Access Compliance Report

Public Rights-of-Way

Intersection ID: 9897		Main Street: N_GRAHAM_ST		Cross Street: W_24TH_ST		Location:		SE	
ADA ID: DADDACCBCF5D		Ramp Type: PerpDiag		Initial Pass/Fail: Fail		Overall Compliance: No		Severity Score: 10	
Codes/Mitigation Info/Possible Solution					Field Measurements/Component Compliance

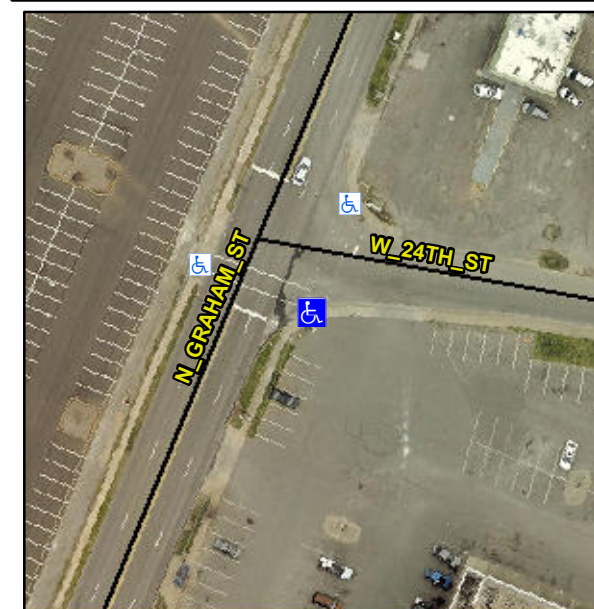
Not Found, R304.5.1, R304.5.3

Compliance	Description	Data	Compliance	Description	Data
N/A	Ramp Length (in)	60.0	Yes	Ramp Slope (%)	7.6
No	Ramp Width (in)	43.0	No	Ramp XSlope (%)	2.9
N/A	Flare Type LT	N/A	N/A	Flare Type RT	N/A
N/A	Flare Slope LT (%)	N/A	N/A	Flare Slope RT (%)	N/A
N/A	Flare Traversable LT?	N/A	N/A	Flare Traversable RT?	N/A
N/A	Landing Length (in)	N/A	N/A	DWS Provided?	N/A
N/A	Landing Width (in)	N/A	N/A	DWS Contrast?	N/A
N/A	Landing Slope (%)	N/A	N/A	DWS Length (in)	N/A
N/A	Landing X Slope (%)	N/A	N/A	DWS Full Width?	N/A
N/A	Landing Curb? (Y/N)	N/A	N/A	DWS Offset (in)	N/A
N/A	Shared Landing?	N/A			
N/A	Gutter Ponding?	N/A	N/A	Gutter Slope (%)	N/A
N/A	Gutter Lip Ht (in)	0.5	N/A	Gutter X Slope (%)	N/A
N/A	Painted X Walk1?	Yes	N/A	Painted X Walk2?	Yes
	X Walk 1 Direction	To NE		X Walk 2 Direction	To NW
N/A	X Walk 1 Width (in)	110.0	N/A	X Walk 2 Width (in)	109.0
	X Walk 1 Slope (%)	3.2		X Walk 2 Slope (%)	0.1
	X Walk 1 X Slope (%)	2.4		X Walk 2 X Slope (%)	3.5

Remove & Replace Curb Ramp With Two New Directional Ramps or Equivalent.
